Access Compliance Report

Public Rights-of-Way

| Intersection ID: 29760 | Main Street: CREEK_POINTE_DR | Cross Street: FAWN_HILL_RD | Location: SW |
| ADA ID: 50A8464FAD13 | Ramp Type: Perp | Initial Pass/Fail: Fail | Overall Compliance: No |

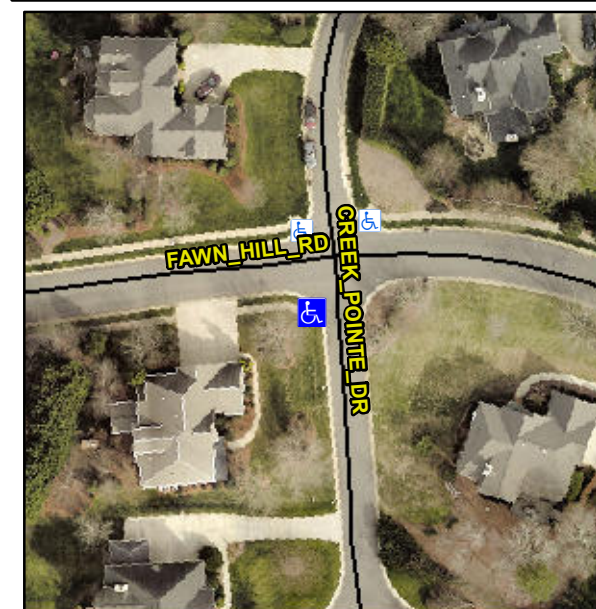
Not Found, R304.5.1

| Compliance | Description | Data | Compliance | Description | Data |
|------------|-----------------------|------|------------|-----------------------------|------|
| No | Ramp Width (in) | 47.0 | Yes | Ramp XSlope (%) | 2.0 |

Remove & Replace Entire Ramp.
